Santa Ynez Landscaping
Project No. FM110334S/988768

Addendum No. 3

ADDENDUM NUMBER 3

August 3, 2011

PLANTING AND LANDSCAPE LIGHTING PLAN

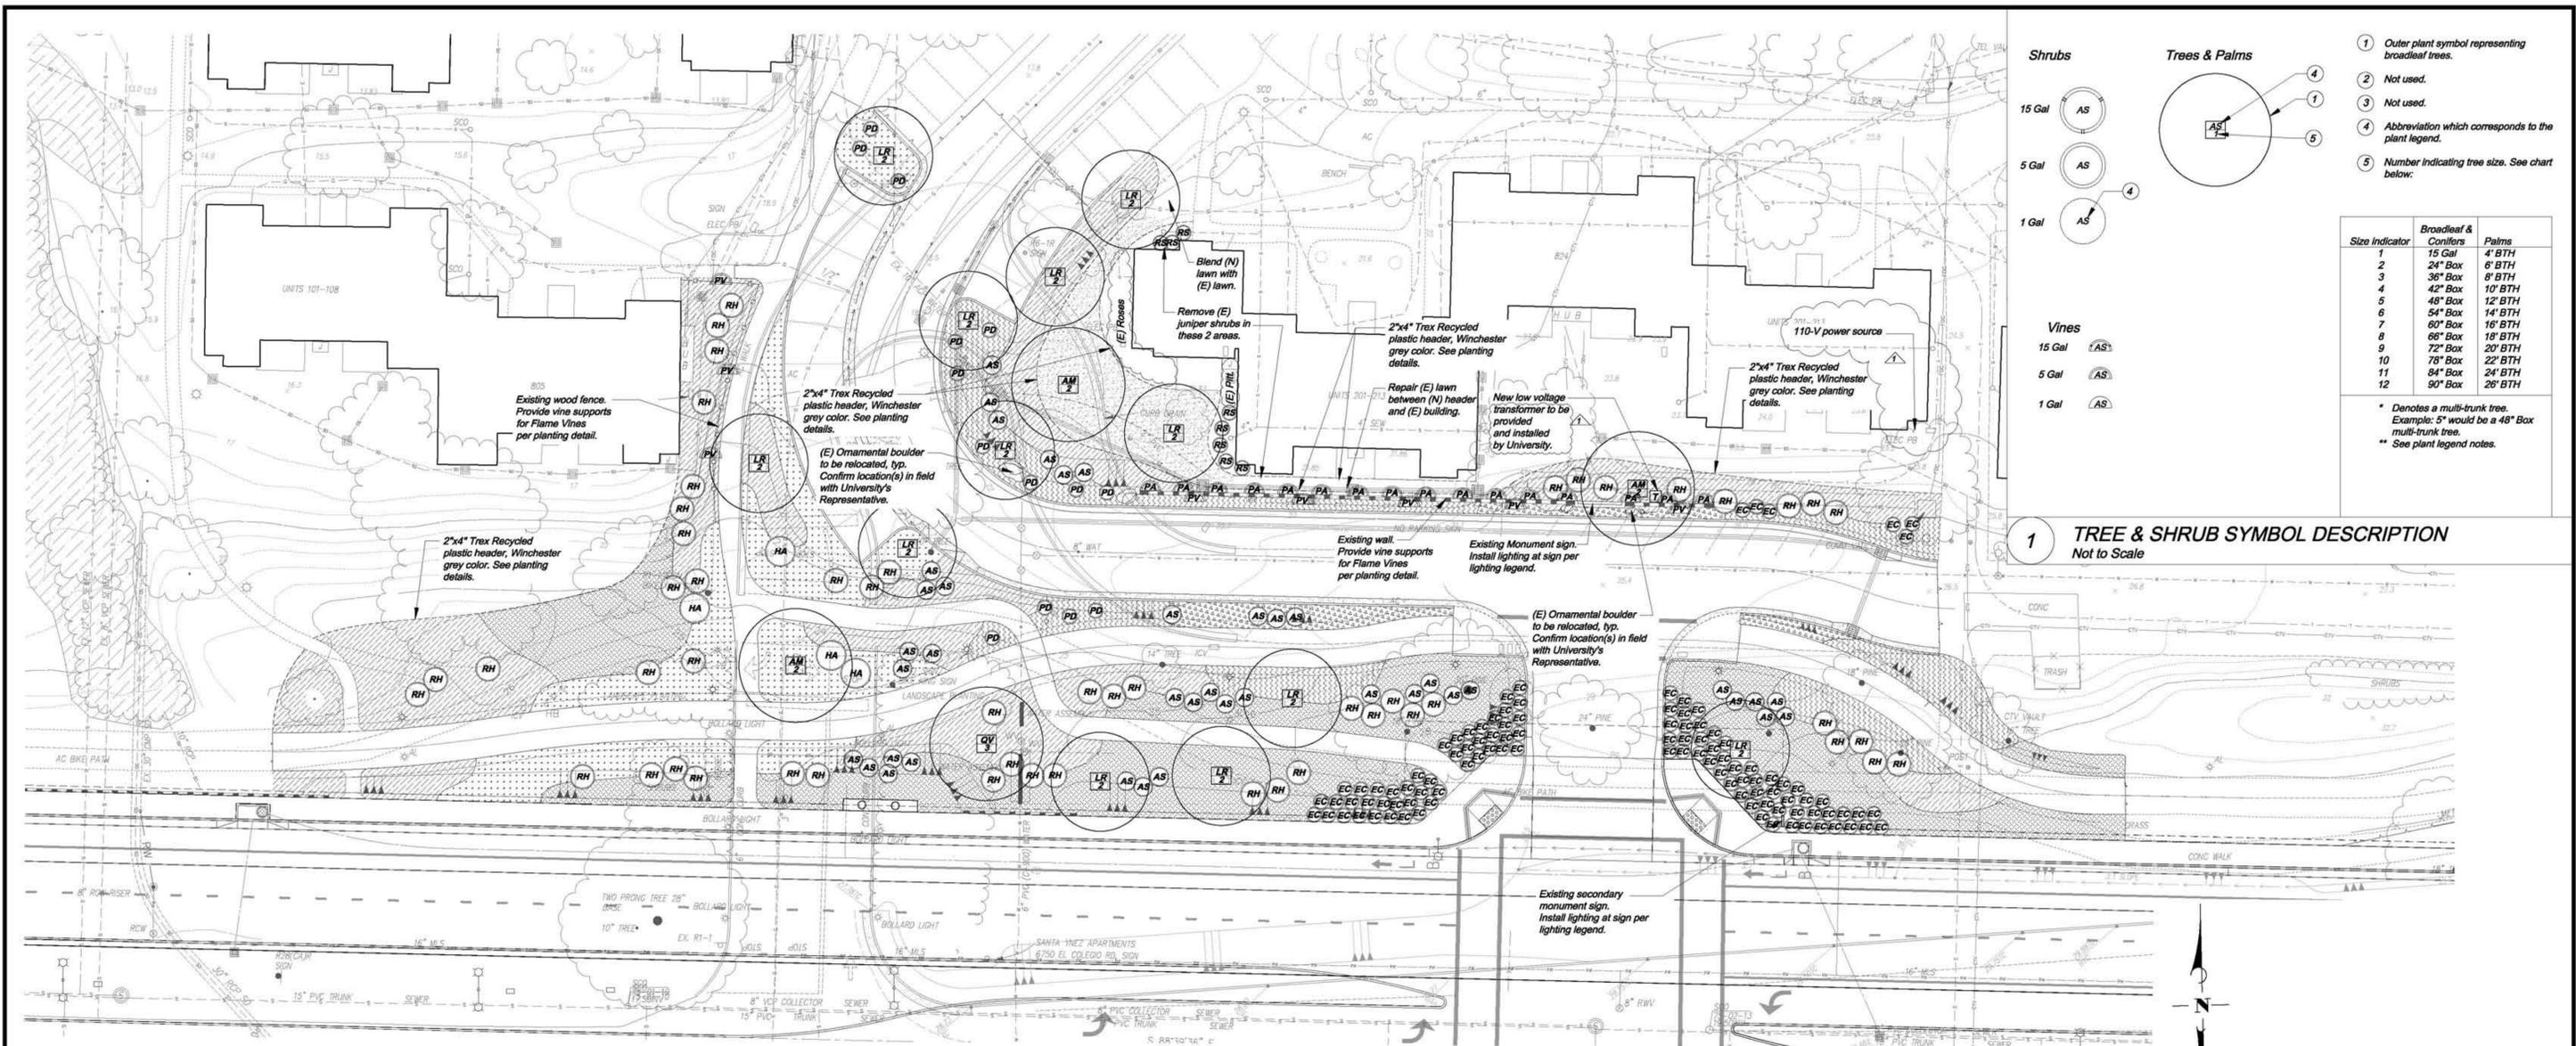
1. DRAWING NO. L5 - PLANTING AND LANDSCAPE LIGHTING PLAN Dated 06/15/2011 **Replace** in its entirety with DRAWING NO. L5 - PLANTING AND LANDSCAPE LIGHTING PLAN Dated 07/29/2011
Revised as follows:
Note Added: Identifies the location of 110volt power source for the lighting system.
Notes revised: Notes regarding the lighting system and lighting components are revised.

NO.	DATE	REVISIONS	R.P.P.D.
1	2011.07.28	Lighting addendum.
